ADDENDUM #07
TO
INVITATION TO BID #01

WESTERN CONNECTICUT STATE UNIVERSITY
RENOVATIONS TO
HIGGINS HALL & HIGGINS ANNEX

STATE PROJECT NO: BI-RD-290-CMR

100% CD BID PACKAGE SUPPLEMENT NO. 04

Set: 58.0

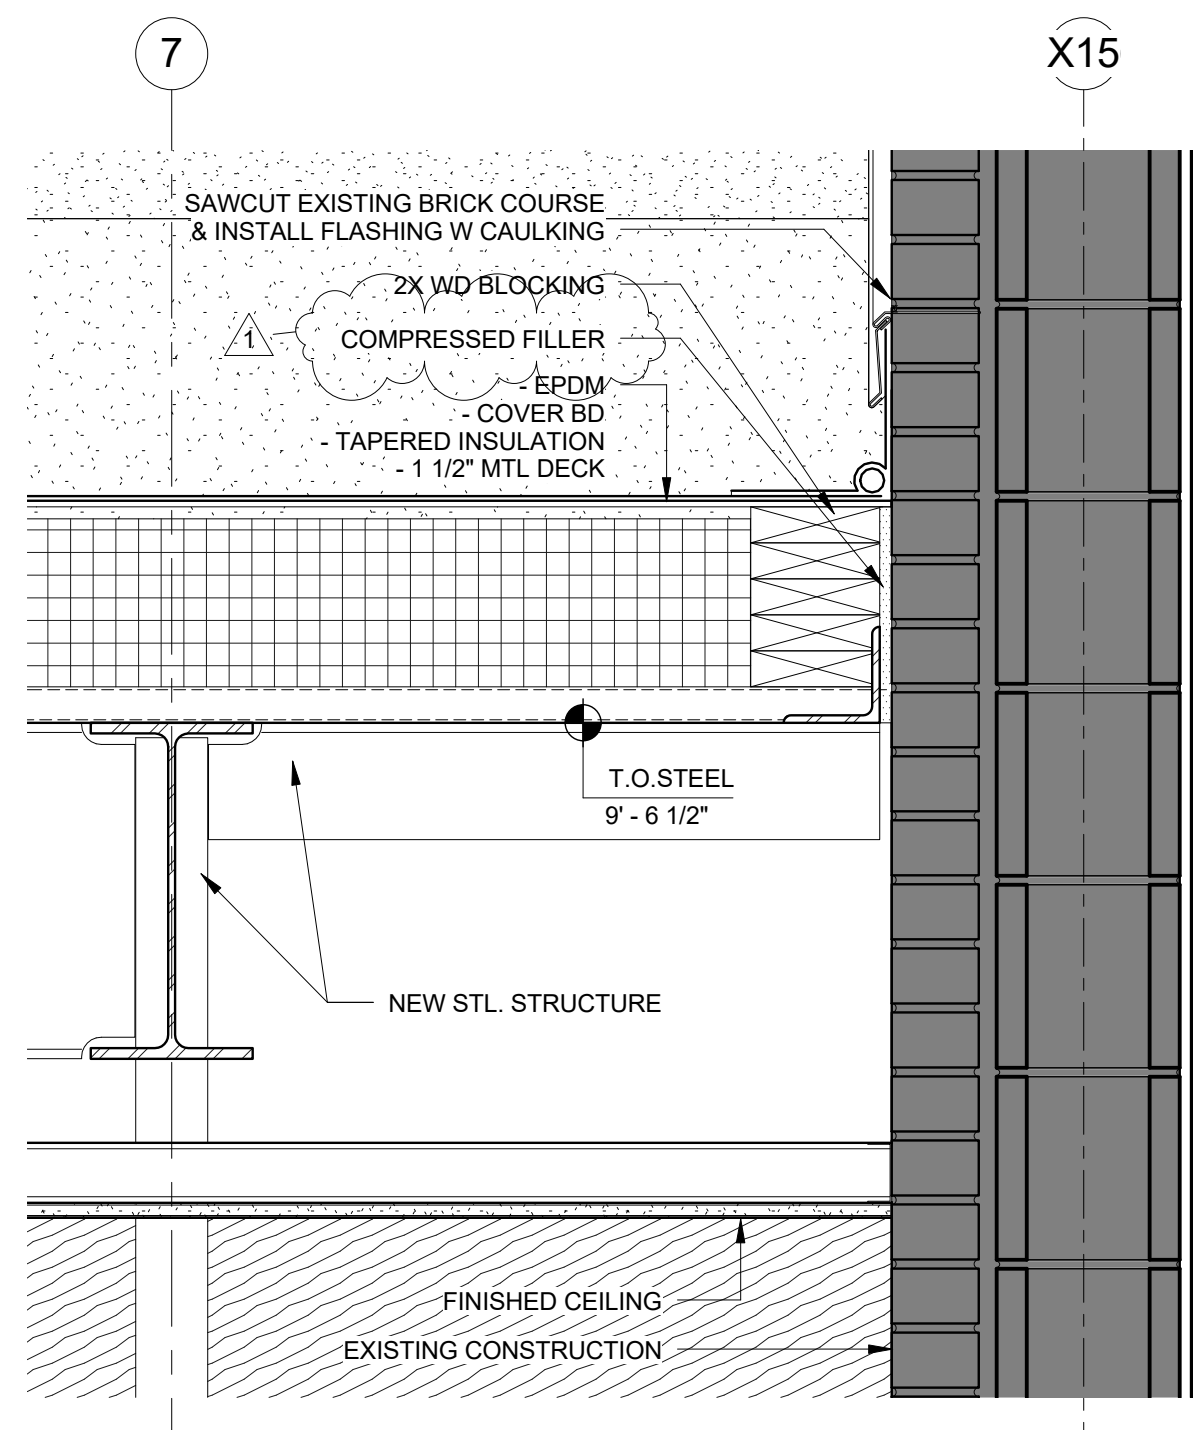
7. A11.01:
 - V103A; Change hardware set to #58.

8. 087100 – Door Hardware:
 - Add hardware “*KR Mullion, 907BKM CT7R, RU*” to Set #9.
 - Change Door V103A set to new set #58 added to this supplement.

6 Hinge (heavy weight)	T4A3786 4-1/2" x 4-1/2"	US26D	MK
1 KR Mullion	907BKM CT7R		RU
2 Rim Exit (storeroom)	ED5200A N910 M54	630	RU

1 LFRC Permanent Core	8027 CKC2	626	RU
2 Surface Closer (stop)	DC6210 A11 M54	689	RU
2 Kick Plate	K1050 8" BEV CSK	US32D	RO
1 Perimeter Gasket	S88BL		PE
1 Mullion Gasket	5110BL		PE

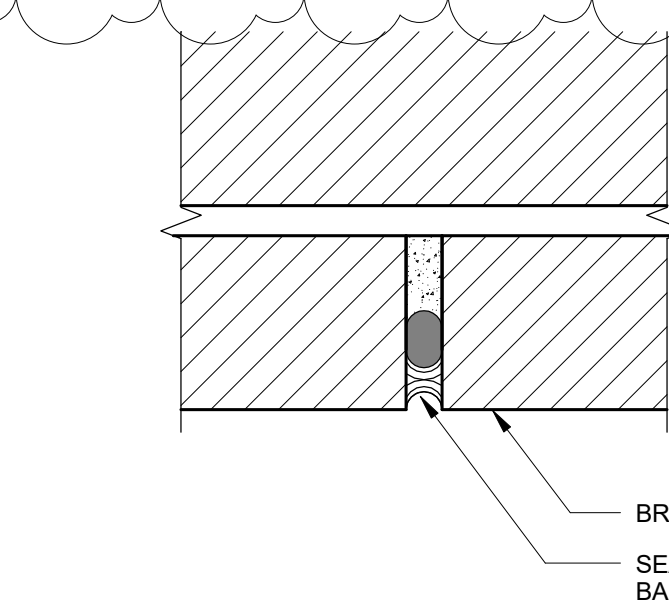
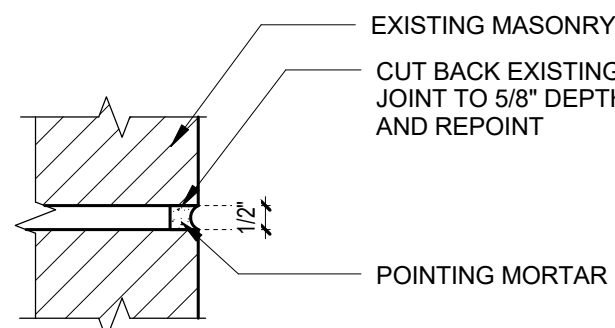
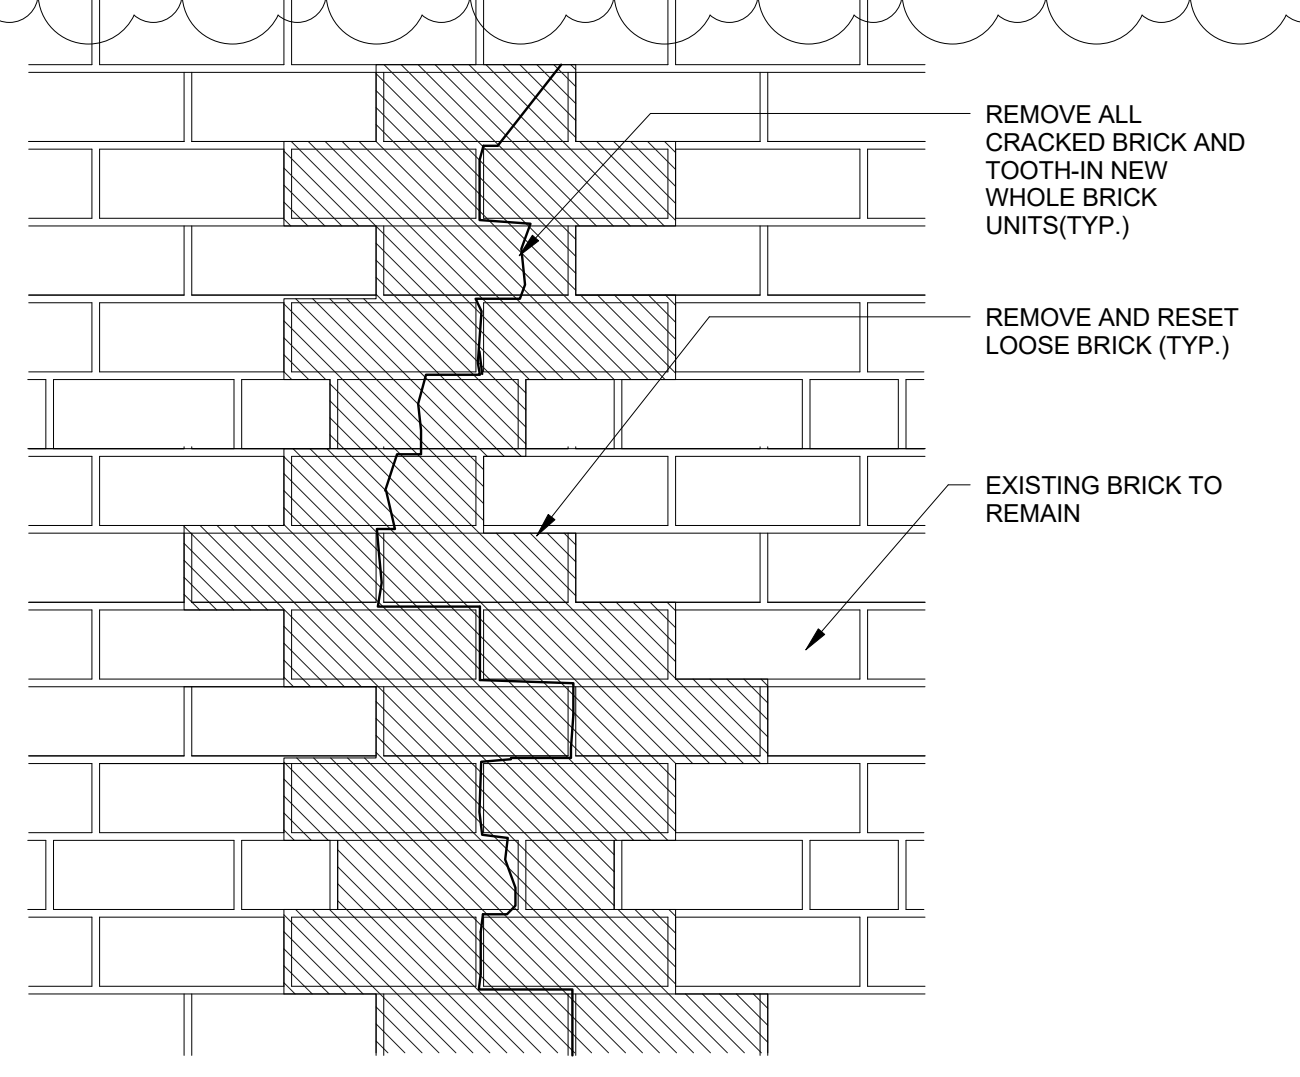
Bidders on **BP #4.1 – Masonry & Stone** should note new lintel requirements shown in these revised drawings.

2. A3 SERIES EXTERIOR ELEVATIONS:
- Replace elevation key note #3 as follows: "REMOVE EXISTING BRICK, TEMPORARILY SUPPORT BRICK MASONRY AND DEVICES ABOVE. REPLACE FLASHING AND BRICK MASONRY W/ NEW & SALVAGED BRICK - SEE DETAIL 1, 2 & 3/A4.41"
3. A4.21:
- Replace drawing with revised A4.21.
4. A4.22:
- Replace drawing with revised A4.22.
5. A4.31:
- Replace drawing with revised A4.31.
